Harris Lake County Park BID ADDENDUM #2

Bidders on this Harris Lake County Park Improvements are hereby notified that this Addendum shall be attached to and made part of the above-named Project Manual dated March 7, 2025.

NCDEQ EROSION CONTROL
HARRIS LAKE
COUNTY PARK IMPROVEMENTS

C5.22

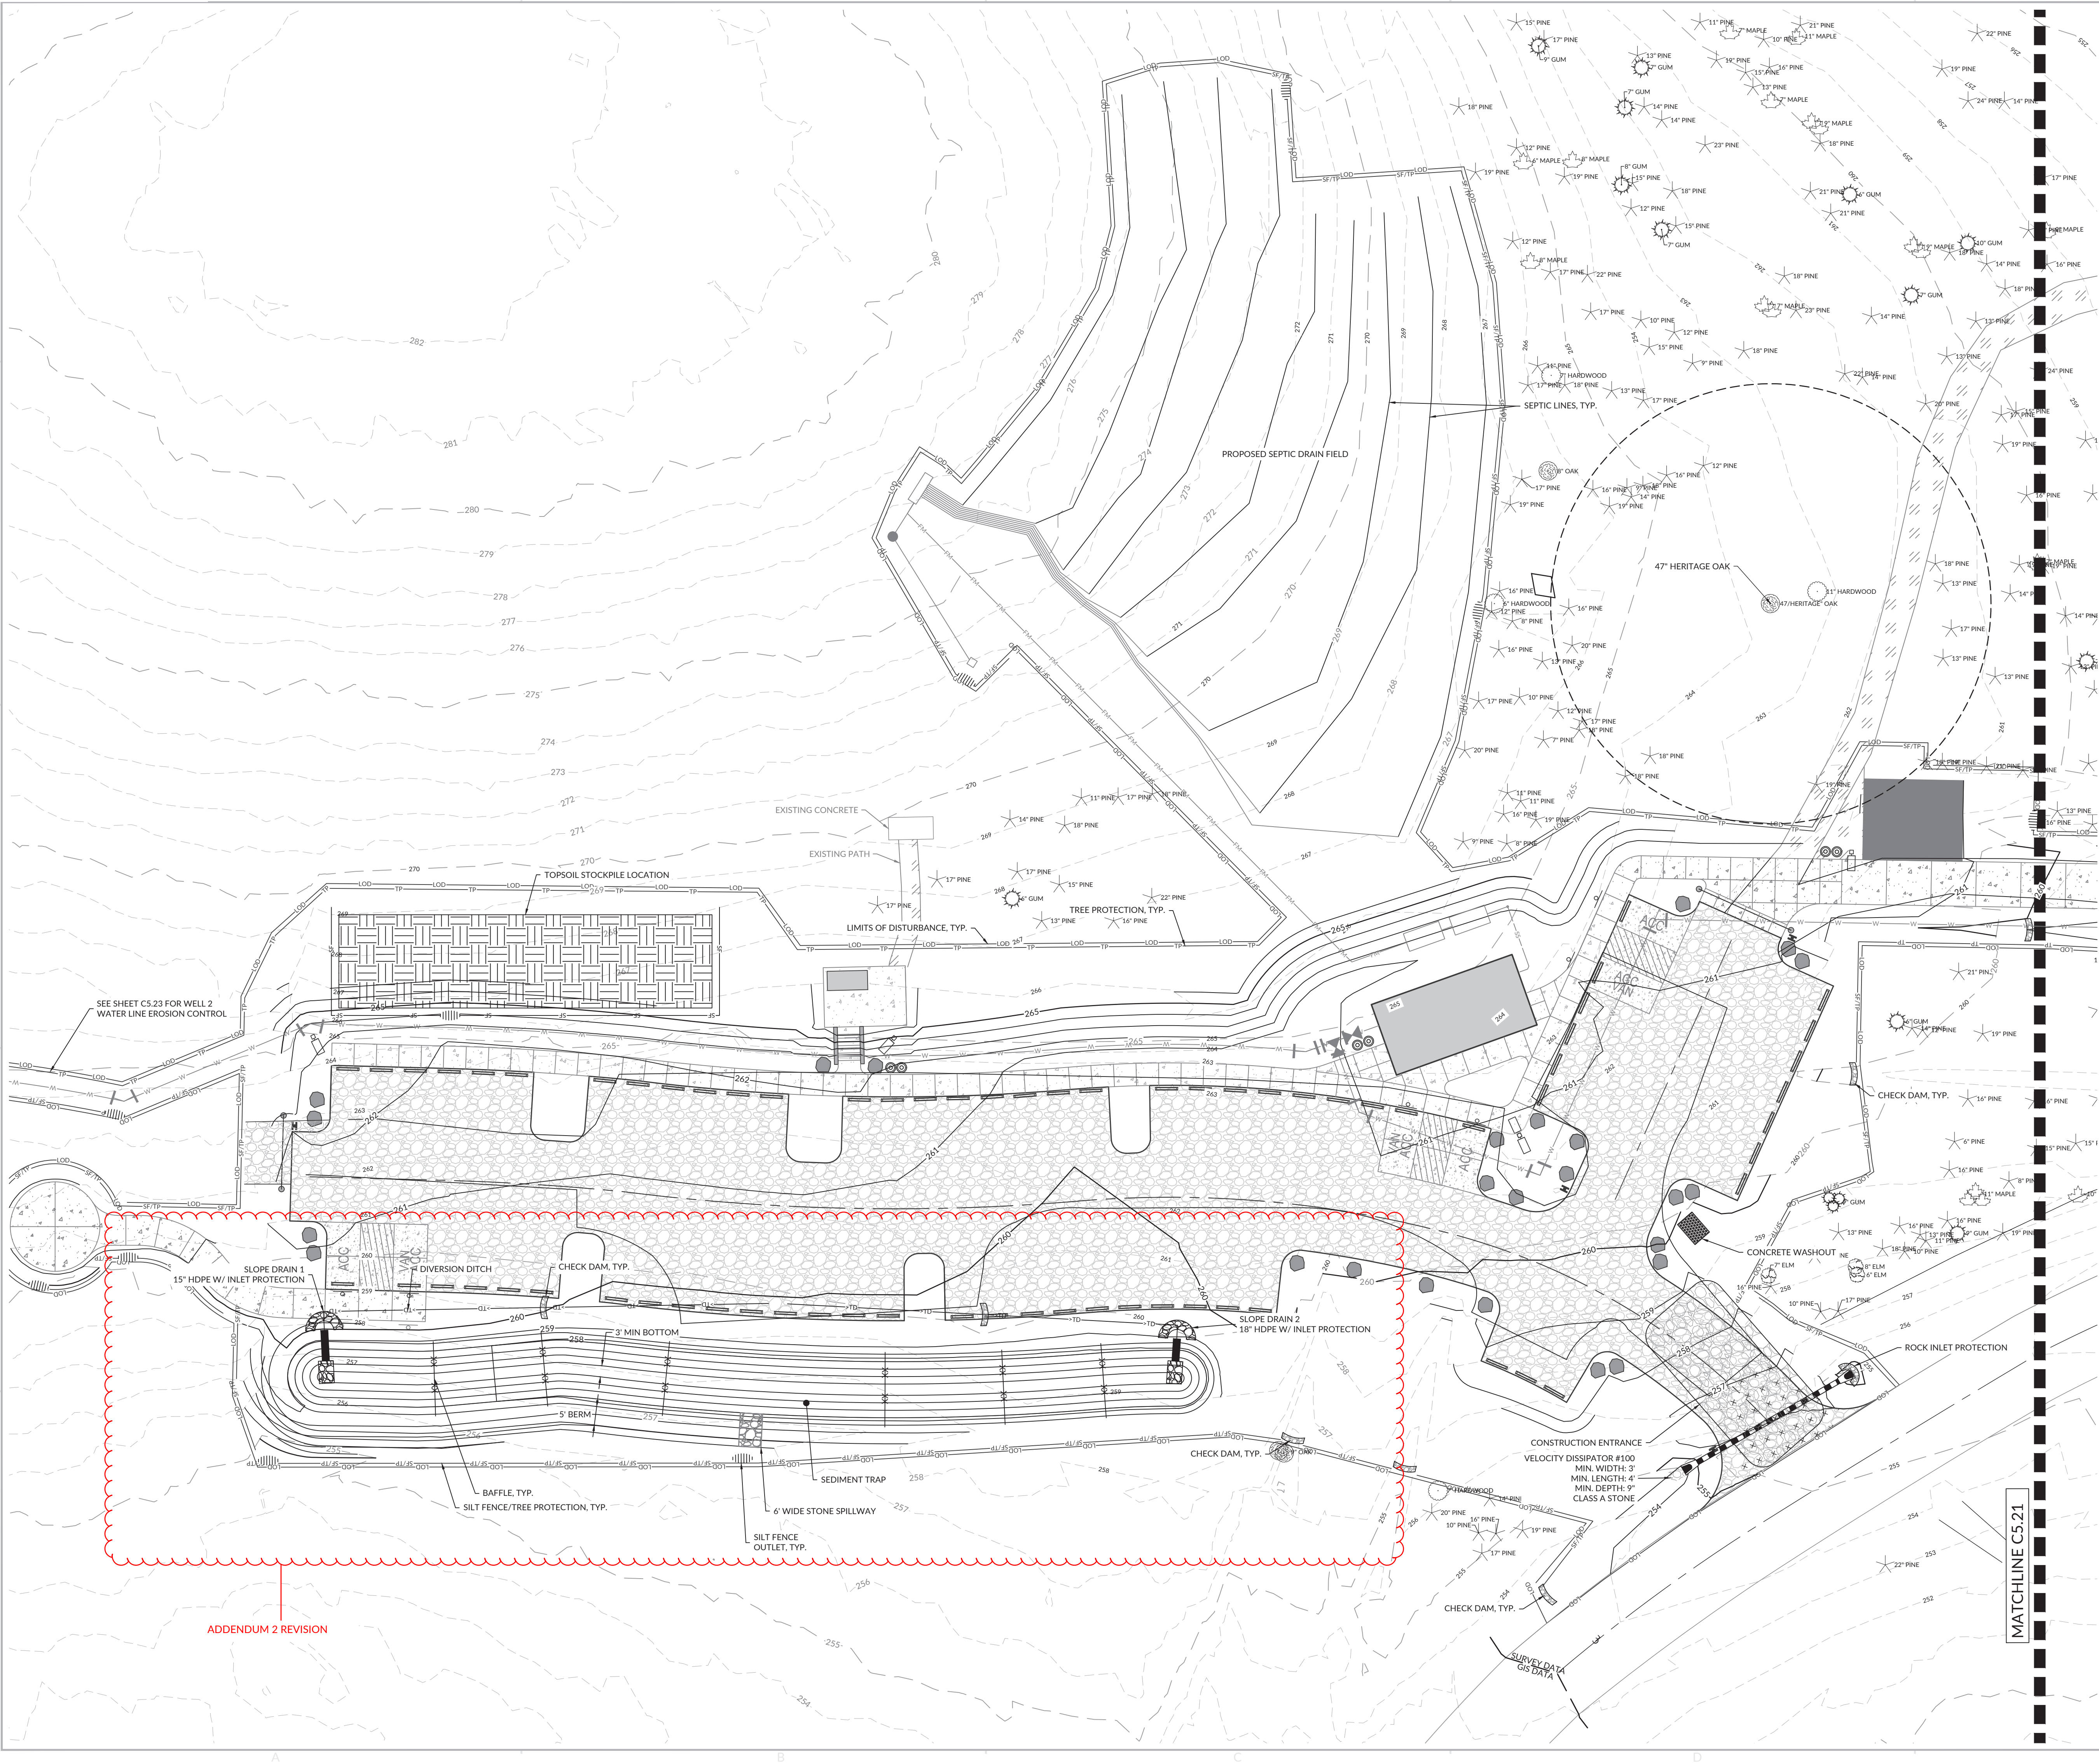
1. Sheet C5.22 – Erosion Control – Disc Golf Parking. Add sediment basin as shown on the plans
2. Sheet M.2.50 – Park Office Details. Refer to Detail A1 General Notes
